**CORRIGENDUM- VI**

**Name of work: Design and Construction of Viaduct in Reach-3 between Jhansi Rani Square and Lokmanya Nagar Stations from Ch 7825m to 18212 m on the East-West Corridor of Nagpur Metro Rail Project.**

**Tender no (As per NMRCL): N1C-08/2016**

**Date: 18/06/2016**

TYPICAL DETAILS OF WALKWAY

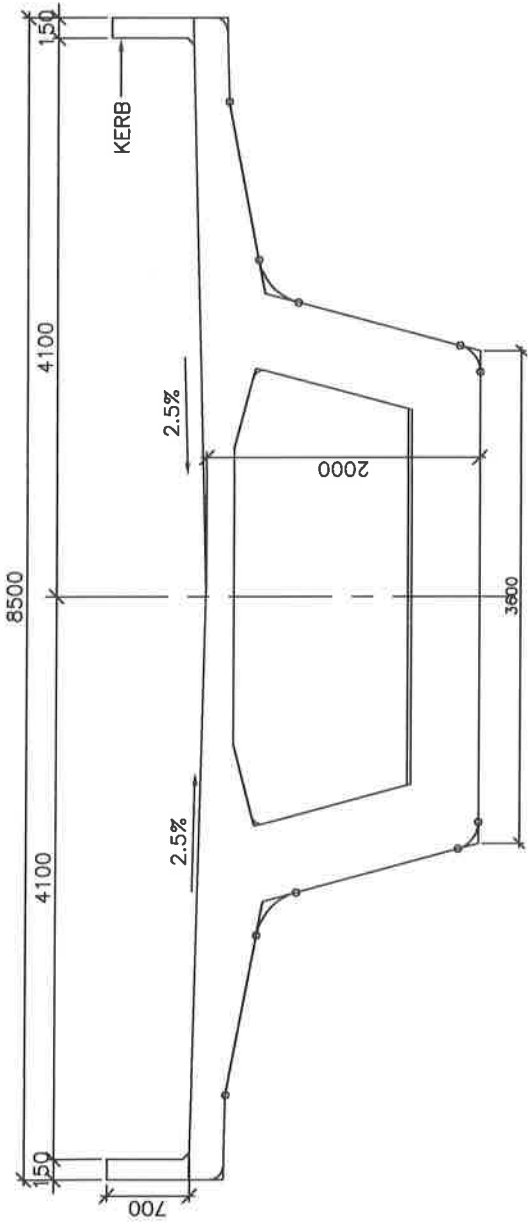
2.	Corrigendum V	S.No: 16	Additional scope: Maintain Rail levels and Lake view Walkway support between Ambazari and Subhash Nagar stations.	The rail level between the stations Subhash Nagar and Ambazari from chainage 12856.232m to chainage 12294.828m is to be considered as 13.5m from ground level. The piers between the chainages shall be designed to support a pedestrian walkway of width 8m. The RFP includes construction of intermediate Pier Caps which will support this walkway. Cost of walkway is not to be considered in present RFP.	As we have deficient rail heights in meeting 13.5m criteria in this stretch, please clarify whether we need to modify the vertical alignment?  We understand that the intermediate pier caps to support the proposed walkway has to be designed and constructed by the viaduct contractor. Please confirm if our understanding is correct.  If so, please provide the locations of the pier caps, loading details and GAD for walkway arrangement.	Yes, due to this revised requirement. Vertical alignment will alter. Bidder to take note of it.  Yes, your understanding is correct.  A tentative drawing of walkway is enclosed herewith. The loads of walkway may be calculated at bidders end.

12.					Please confirm that: Walkway will be supported on existing viaduct piers only (on the intermediate pier caps to be constructed below the main pier caps)	Yes. Hence please note that the cost of walkway is not to be included in lumpsum rate of present RFP. But foundation and substructure must be designed to support load of the walkway. To support this walkway, contractor need to construct intermediate pier cap as shown in the enclosed sketch.

**TYPICAL CROSS SECTION OF SEGMENTAL BOX GIRDER**

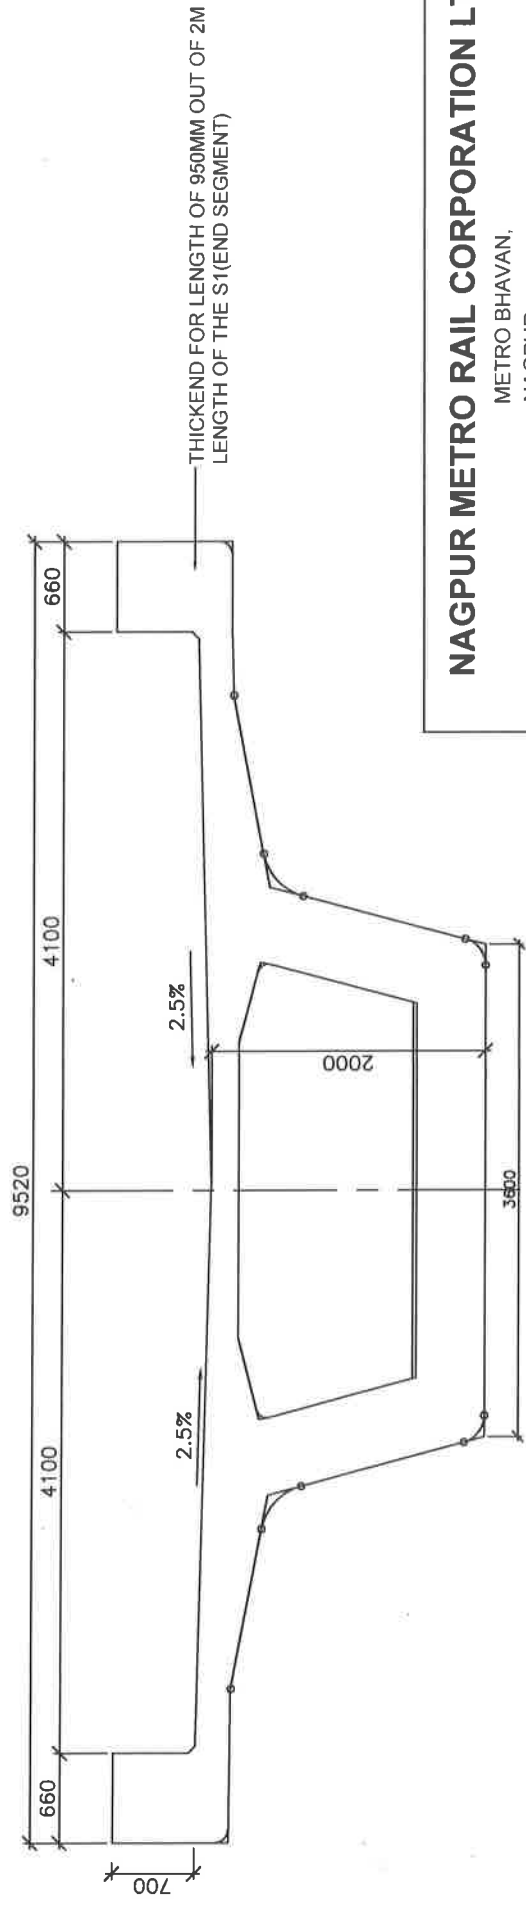
Sl. No	Page/Section No	Clause No	Description	Existing Provisions	Queries/ Requests	Clarification / Amendments
		t DBR				
6.	Corrigendum V	Annexure	Segment Dimension	Section for Segments S2 & S7, Typical Section 4-4 at Diaphragm has given.	Please provide Web thickness for all the sections, mid-section details and also provide complete set of super structure GAD's.	Please refer enclosed sketch.

7.	Corrigendum V	Annexure	Segment Dimension	Section for Segments S2 & S7, Typical Section 4-4 at Diaphragm has given.	Our understanding from drawing is infill segments i.e S2 & S7 have a top width of 8.5m and Diaphragm segment has 9.520m. Span formed of these precast segments is discontinuous. Please clarify, is it aesthetically acceptable.	Please refer enclosed sketch.

8.	Corrigendum V	Annexure	Segment Dimension (Kerb)		Does kerb of 650mm thick on top of diaphragm segment (shown in the drawing) extends full length of segment?	Please refer enclosed sketch. Also, 650 mm thick diaphragm is for a length of 100 mm for S1 segment.

9.	Corrigendum V	Annexure	Pardi Wall	The sketch of the segment attached shows 100mm Thick Pardi wall in Diaphragm segment	Diaphragm wall usually does not have Pardi Wall. Please clarify if it is required and also provide it's GAD for better understanding.	Please see enclosed sketch

11.	Corrigendum V Part-II, Section-VII., (Scope of Work), Page 179 Schedule of	Annexure 2.3 A 1.4.1	Segment S2 & S7 Spacing of Tracks Buildings &	As per the sketch the width of segment is 8.5m Spacing of Track needs to be minimum 4.1m centre to centre. Minimum lateral clearance for OHE mast for tangent track on the viaduct shall be 2150mm from centre line of	If the centre to centre track spacing has to be 4.1m and minimum lateral clearance of OHE mast for tangent track on viaduct has to be 2150mm from centre line of nearest track, the Top width (8.5m) of segments shown in the sketch will not be satisfied (Refer to NMSG-6 of SOD). Please clarify whether it is mandatory to maintain 8.5m. If so, please provide the revised centre to centre spacing	Enclosed sketch indicate dimension for segments including segment (S1) which support OHE mast.
